MUSKOKA RD.#2
(RAVENSCLEIFF RD.) UNDERPASS
GENERAL LAYOUT

FOUNDATION INVESTIGATION REPORT

STRUCTURAL REVIEW COMMITTEE

Ravencliffe Road Bridge (W.P. 74-74-05)

MUSKOKA RD. #2
(RAVENSCLIFF RD.) UNDERPASS
FOOTING LAYOUT

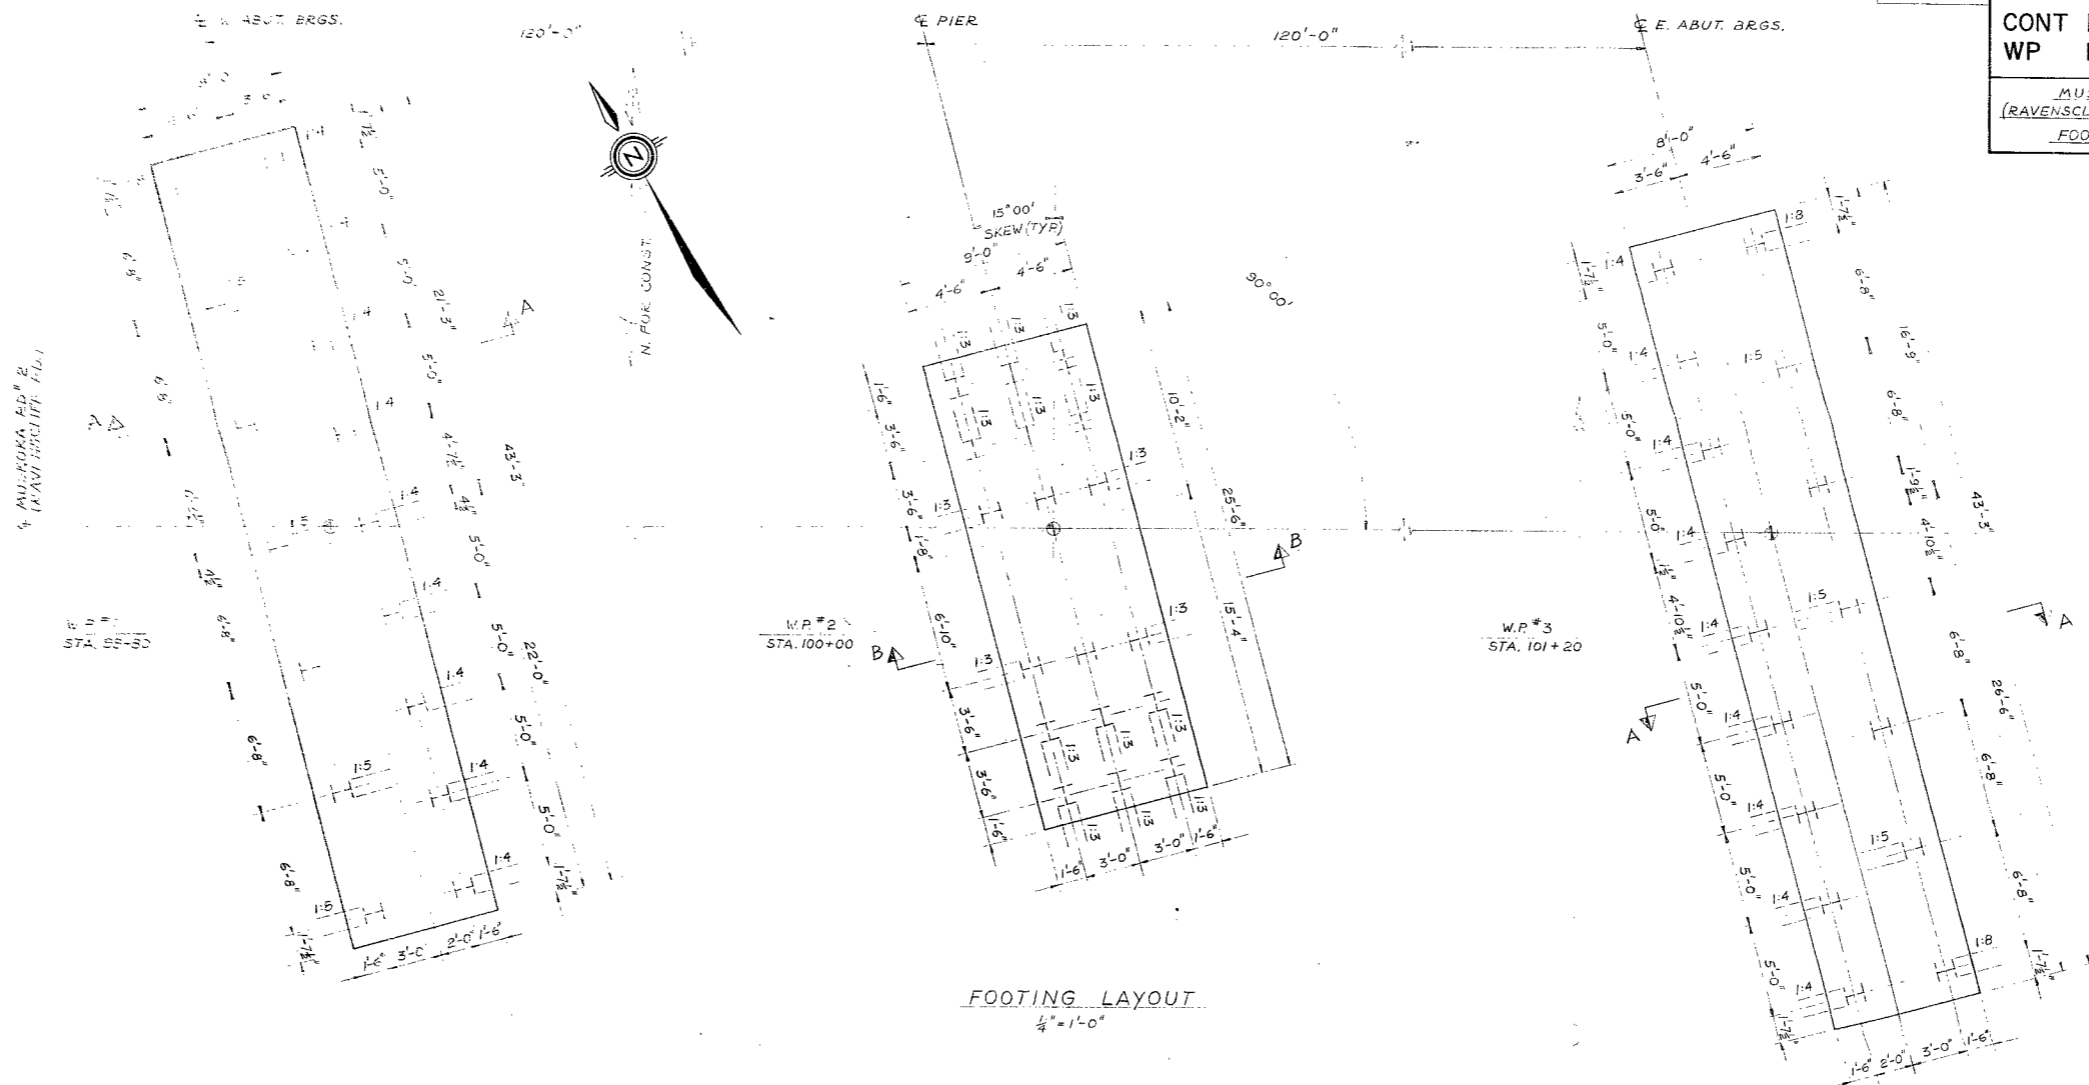
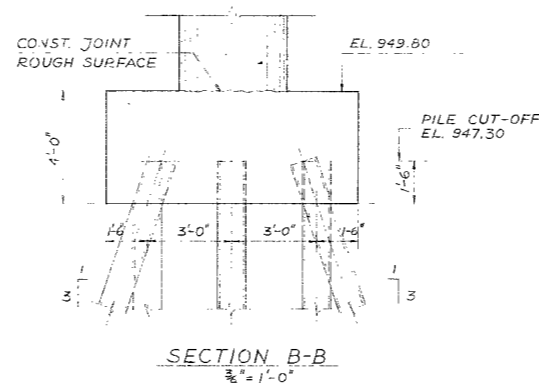
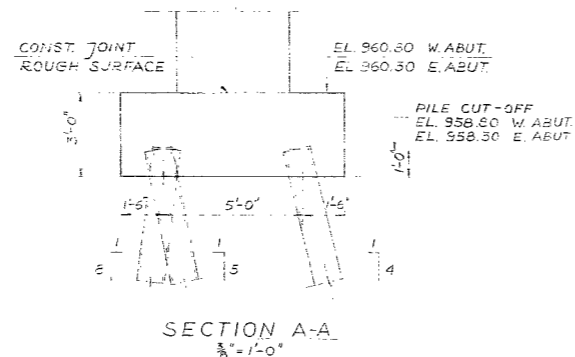
The design complies with the recommendations of the foundation report, however the economy of using HP 12 x 53 section of piles is queried. The Designer is to investigate the feasibility of using less piles with HP 12 x 74 section.
